SECOND STATEMENT OF EVIDENCE OF MICHAEL ANDREW SMITH ON BEHALF OF QUEENSTOWN LAKES DISTRICT COUNCIL

TRANSPORT - GENERAL INDUSTRIAL ZONE

UPPER CLUTHA TRANSPORT LIMITED REZONING

18 March 2020

Figure 1 – submission site

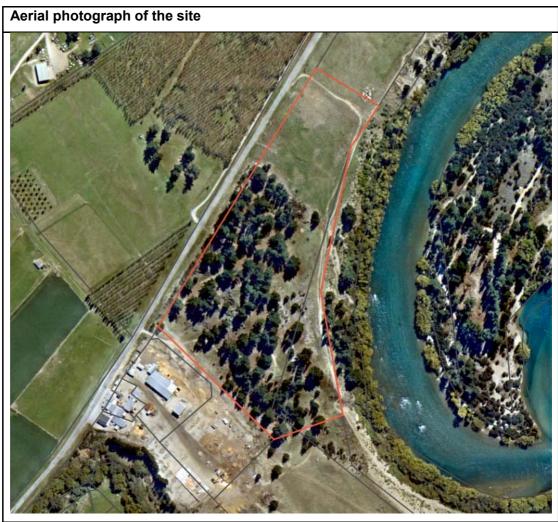
3.1 Upper Clutha Transport Limited (UCT) seeks to change the zoning of 8.02 hectares of a 13.89-hectare site in Luggate from Rural Zone to GIZ. The submission site legally described as Lot 1 DP 300025 and Lot 1 DP 475297, identified in red in Figure 1 below.
